INFORMATION BULLETIN NO. 110A

TO: OWNERS OF J.H. FLETCHER & CO. MODEL DR AND CDR SINGLE MAST FEED ROOF DRILL ONLY

SUBJECT: MAST FEED CYLINDER GUARD * FREE OF CHARGE*****

TITAN MAST GUARD

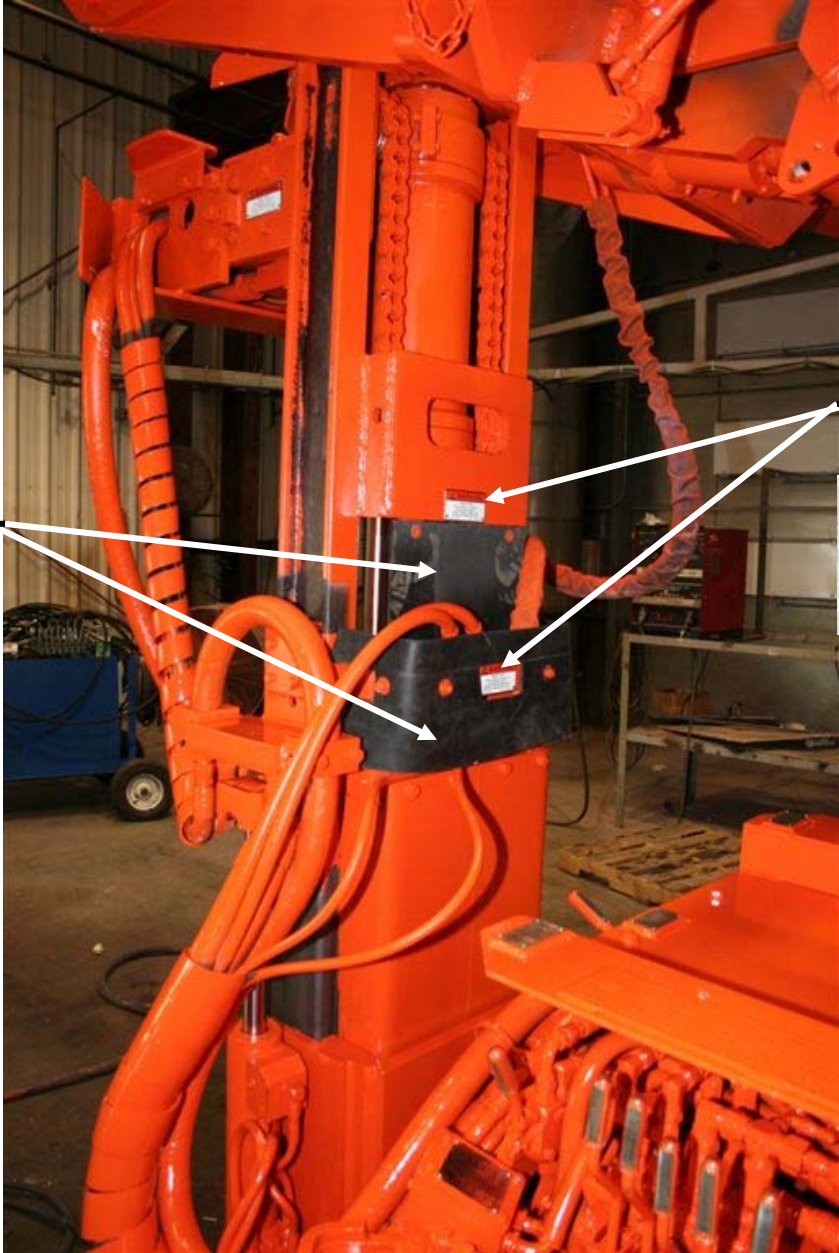
Even though there is no operational need for a roof bolt operator to place a hand, or any body part, between the inner and outer mast during operation, Fletcher is aware that some operators have done so. Fletcher has developed a guard to prevent access to this pinch point area, thereby eliminating the risk of serious injury to the operator. **THIS POTENTIAL SERIOUS INJURY IS PREVENTABLE IF THE MAST FEED GUARD IS INSTALLED.**

The pinch point between the inner and outer mast is created when the drill mast moves up or down during drilling and bolting process. This RAPID mandatory movement of the machine during the bolting cycle can occur hundreds of times during a normal work day.

In order to discourage and prevent an operator from placing a hand or other body part in this pinch point area, Fletcher previously offered this mast feed cylinder guard in Information Bulletin 110 to owners of specific Fletcher DR and CDR roof drills (see photo in Attachment 1).

The mast guard kit (PN: 415666) is offered **FREE OF CHARGE** to any customer who has one of these specified machines. Since the first publication of this important safety notice, Fletcher has had limited customer participation in this retrofit.

GUARD
KIT
PART NO.
415666
